CITY OF NEW BEDFORD
Department of Public Infrastructure
ADDENDUM #2

**The City of New Bedford issues Addendum #2 for
Buttonwood Brook Water Quality Improvements
Bid No. 24450095**

Date Issued: March 12, 2024

RE: City of New Bedford, Massachusetts
Phase 1 – Buttonwood Brook Water Quality Improvements
Bid No. 24450095

Drawing No.:
C-2

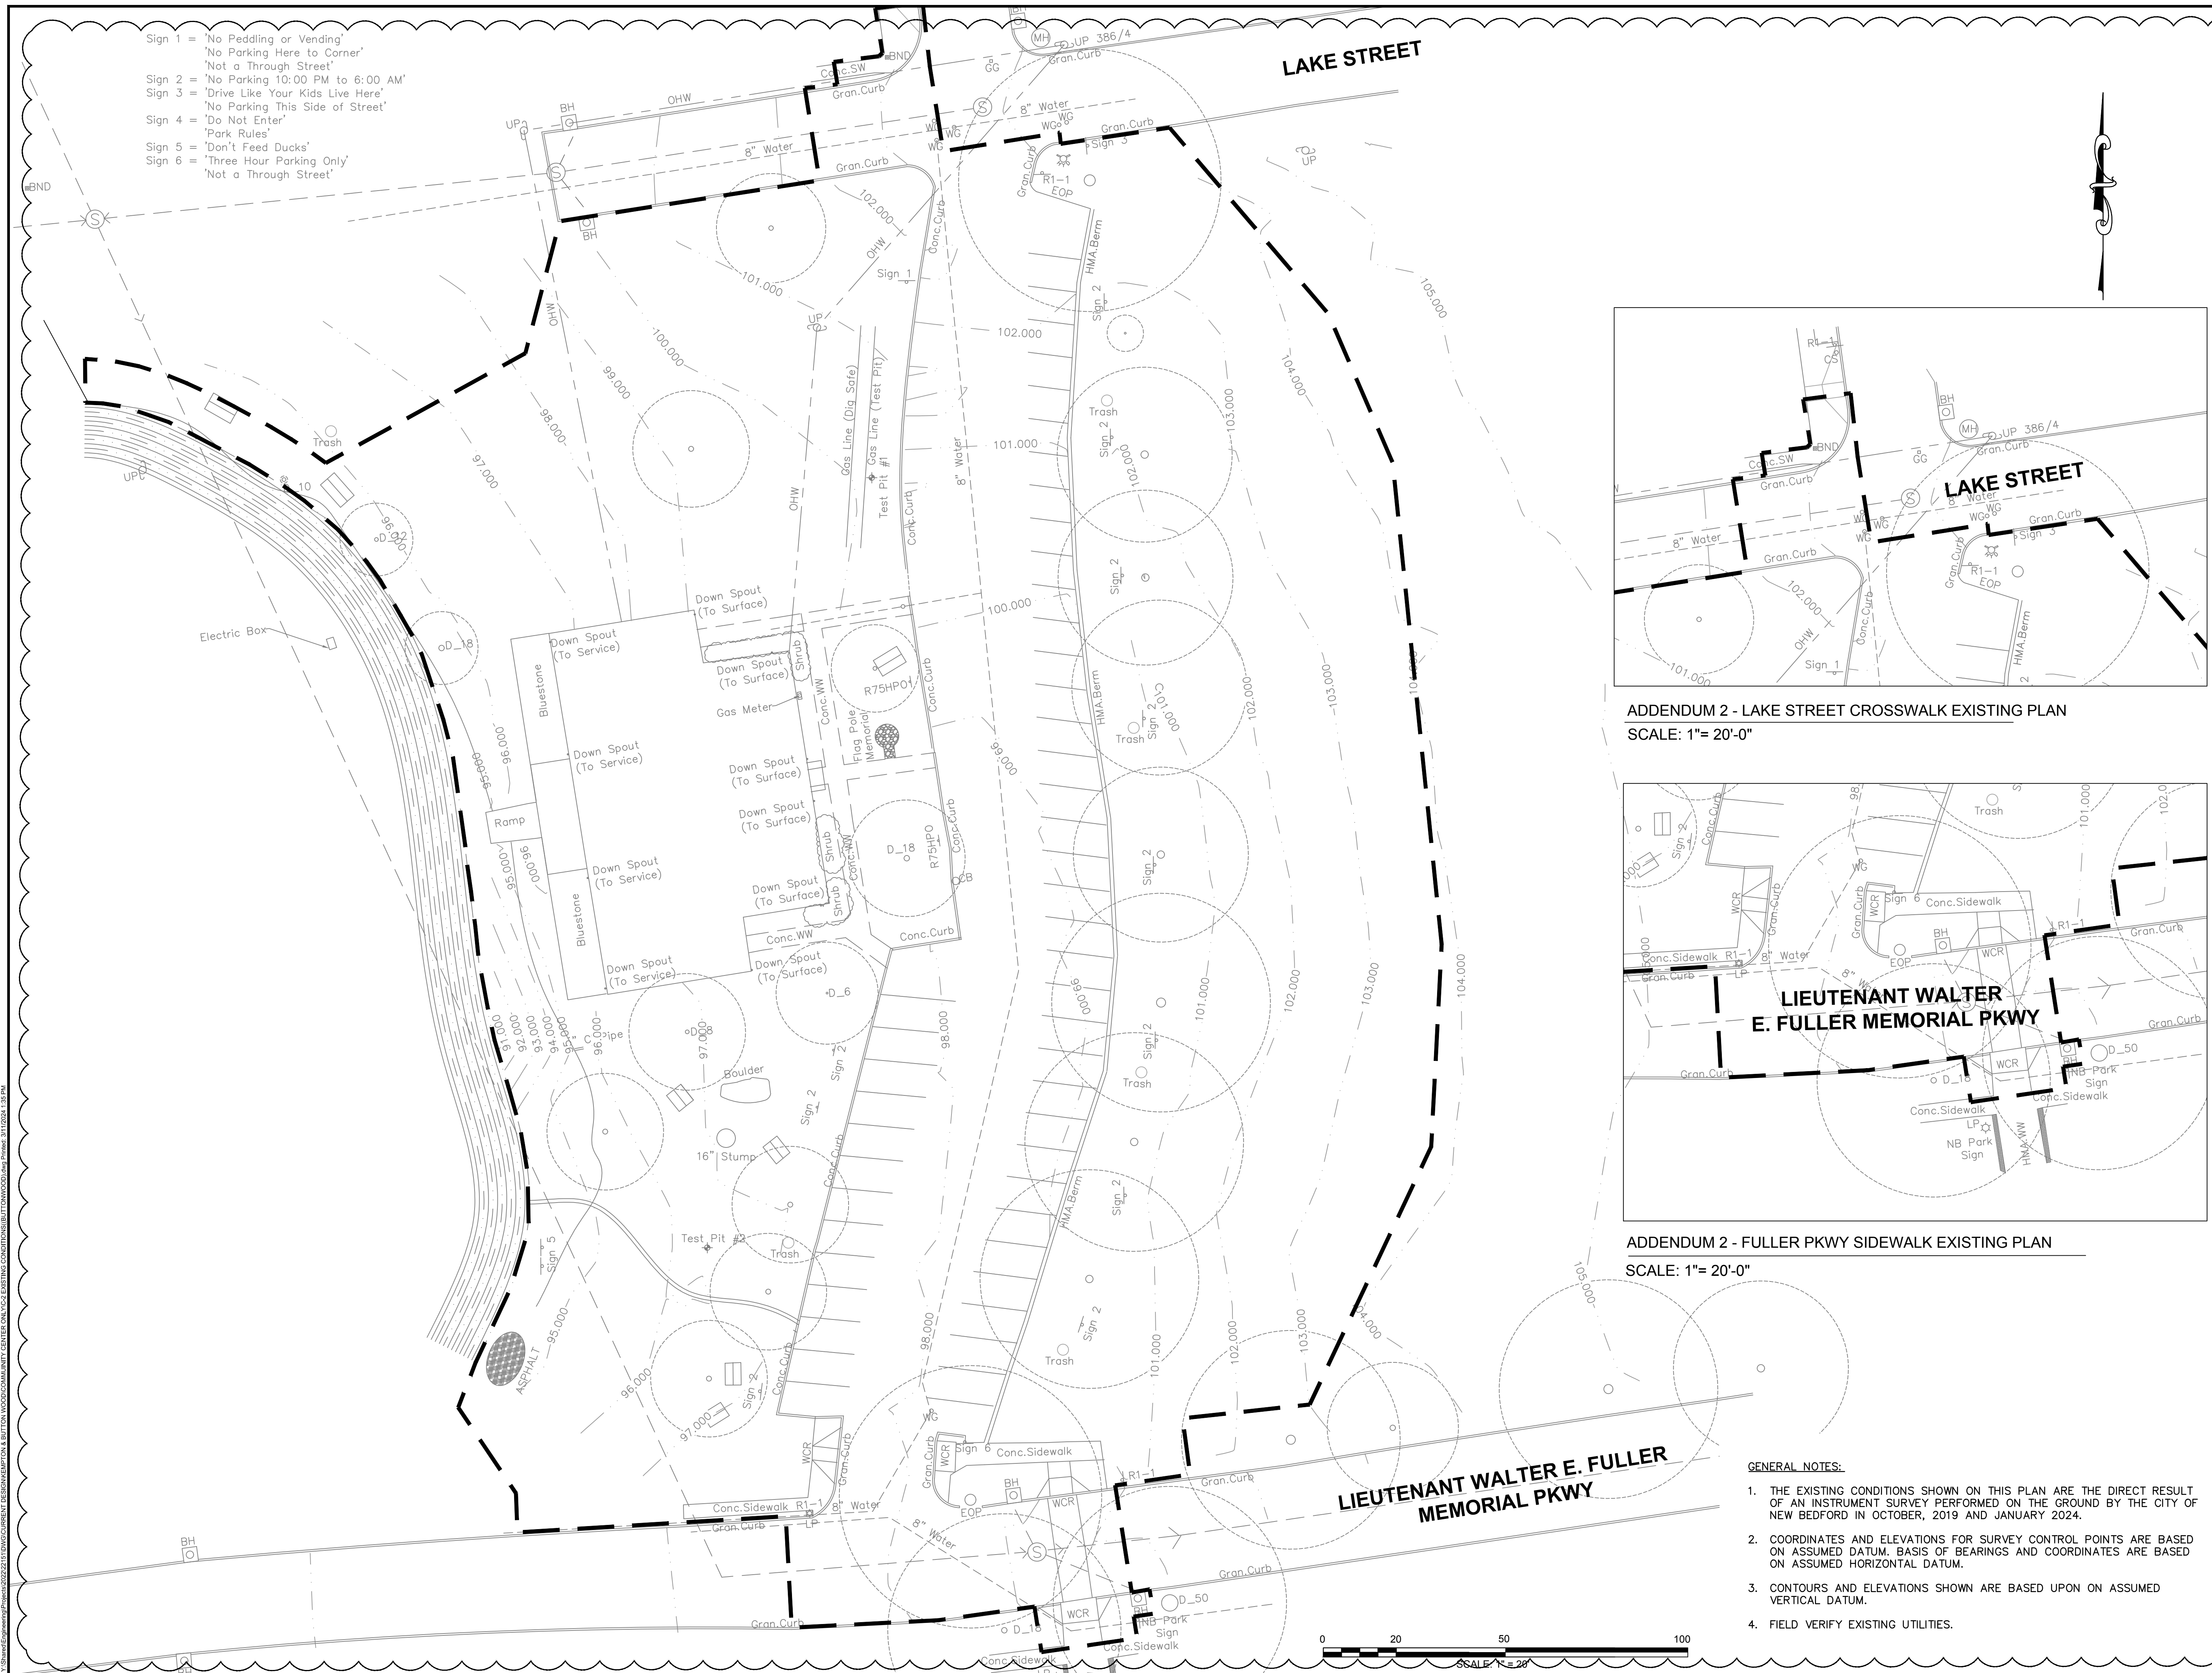
1. C-2 Existing Conditions
2. C-3 Site Preparation and Erosion Control Plan
3. C-4 Site Layout and Materials Plan
4. C-5 Site Grading and Utility Plan
5. C-6 Landscape Plan
6. C-13 Addendum Layout and Materials Plan & Landscape Plan
7. C-14 Site Details 7
